CHARLOTTE - MECKLENBURG
 PLANNING COMMISSION
 INTER - OFFICE COMMUNICATION

DATE: December 13, 1996
 FROM: Martin R. Cramton, Jr.
 Planning Director
 TO: Robert Brandon
 Zoning Administrator
 SUBJECT: Administrative Approval for Petition No. 95-57 by Tommy Lee Nasekos Tax Parcel # 187-261-01

CONDITIONAL REZONING REQUEST
 TOMMY LEE NASEKOS
 C.D. REZONING/SUBDIVISION SITE PLAN
 SHARON VIEW ROAD CHARLOTTE, NC

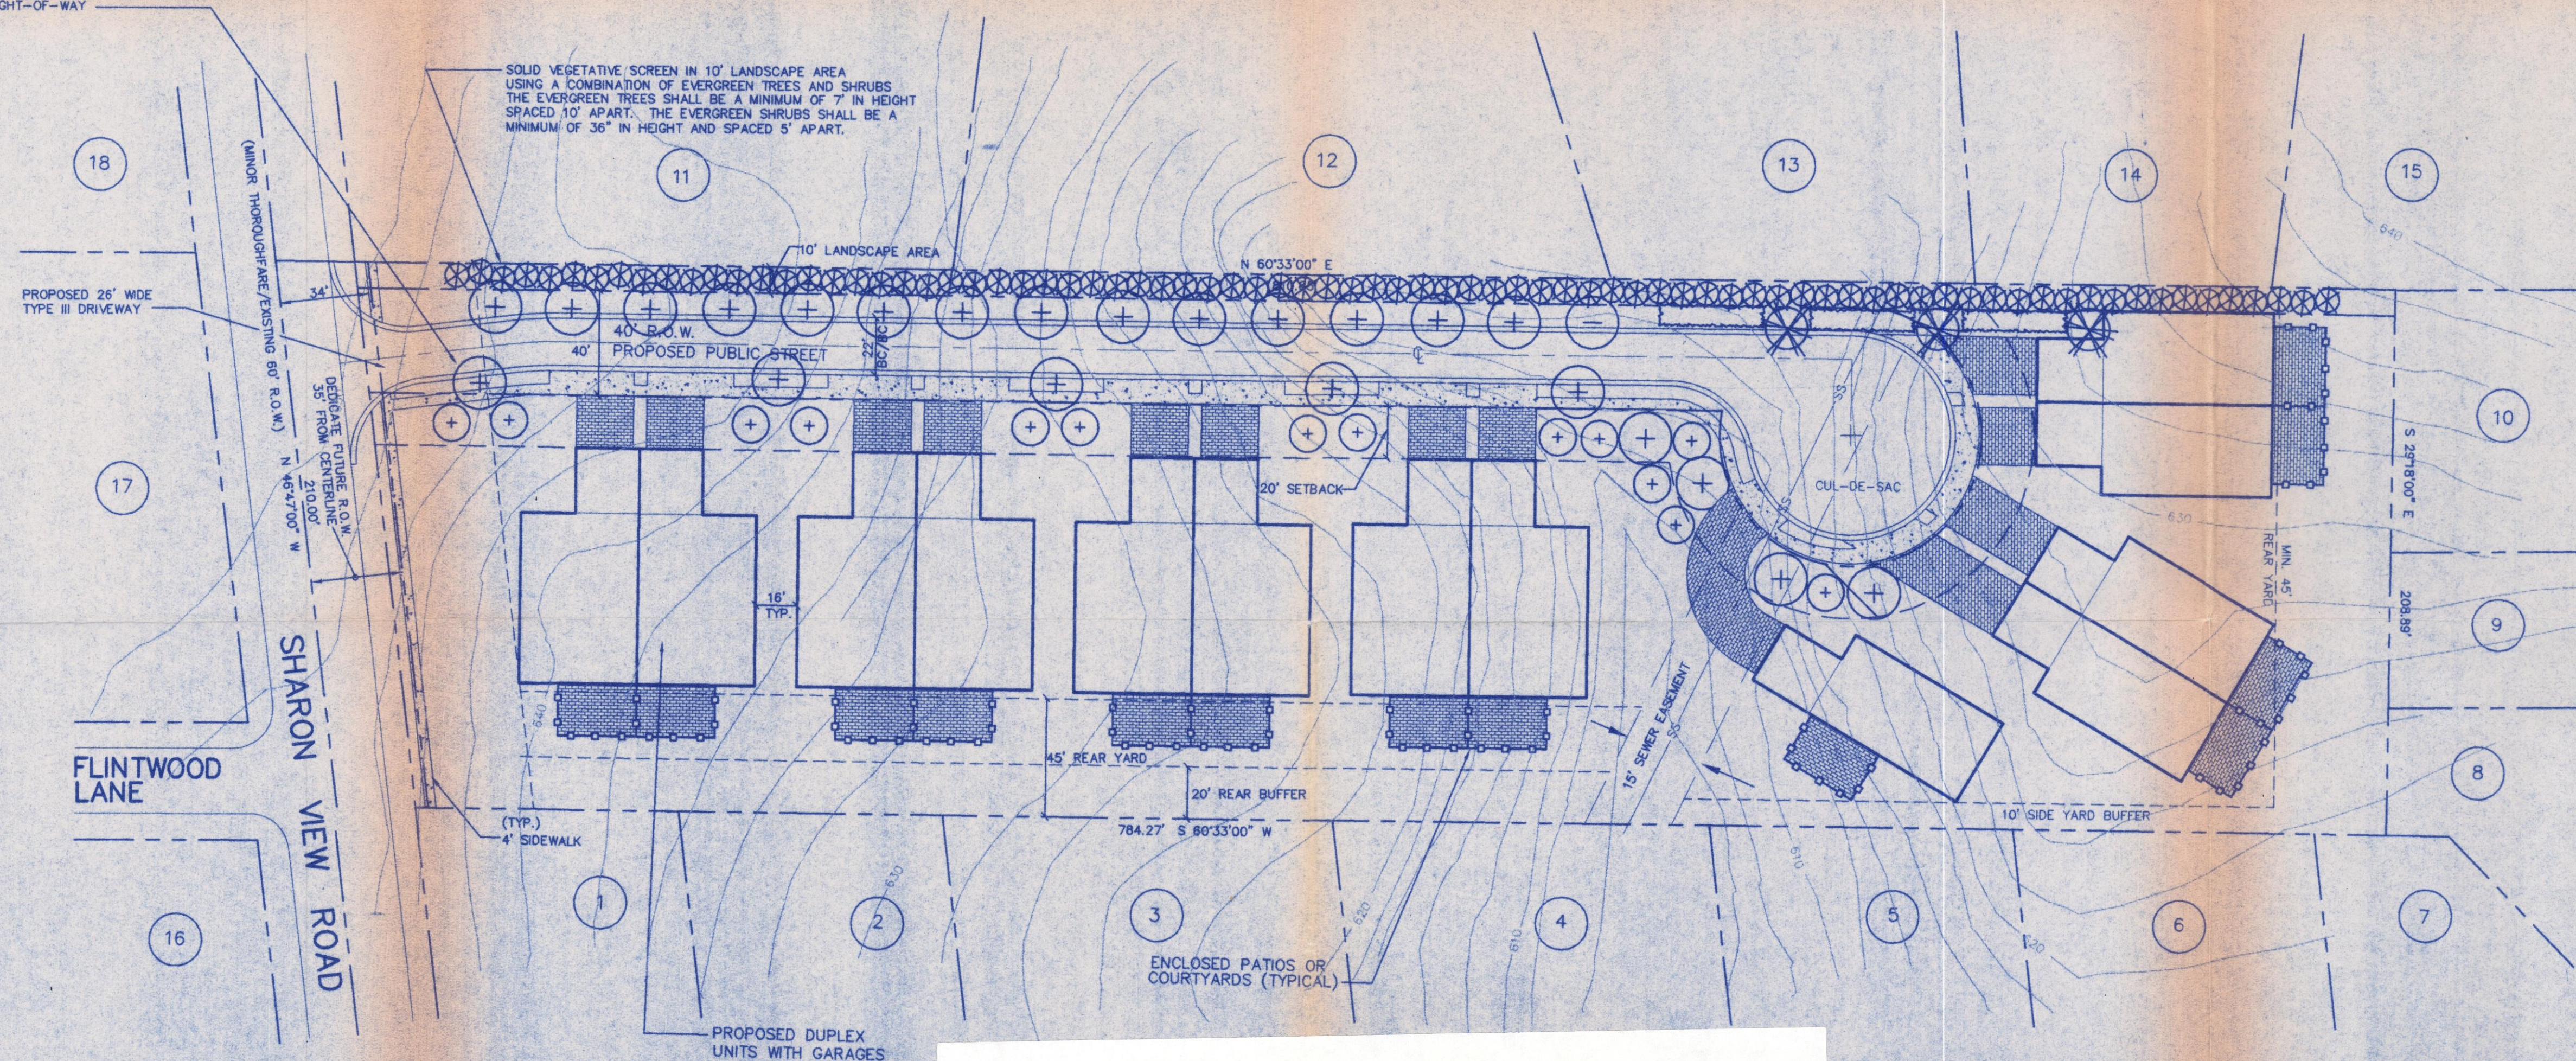
- BASED UPON DISCUSSIONS WITH CITY OF CHARLOTTE ENGINEERING, A MODIFICATION OF THIS CONDITIONAL APPROVAL IS REQUESTED TO ELIMINATE THE REQUIREMENT OF NOTE NO. 8 ABOVE REGARDING STORM WATER DETENTION AND INSTEAD INSTALL OFF-SITE CITY DRAINAGE IMPROVEMENTS. THE OFF-SITE IMPROVEMENTS WILL CONTROL RUNOFF FROM SHARON VIEW ROAD AND DISCHARGE ALL RUNOFF AT AN EXISTING 42" STORM PIPE AT GAYMOND DRIVE. THE AGREEMENTS ARE IN PLACE WITH THE AFFECTED NEIGHBORS.

Attached is a revised plan for the above mentioned rezoning petition. The plan has been revised to delete the requirement for storm water detention and replace it with additional off site drainage requirements. These off-site drainage improvements will do a better job of resolving down stream flooding problems. The City Engineering Department has confirmed that these off-site improvements will be more effective in dealing with down stream flooding than the formerly required storm water detention. Since this change is minor and does not change the effect of the previously approved conditions we are administratively approving this revised plan. Please use this revised plan when evaluating requests for building permits and certificates of occupancy.
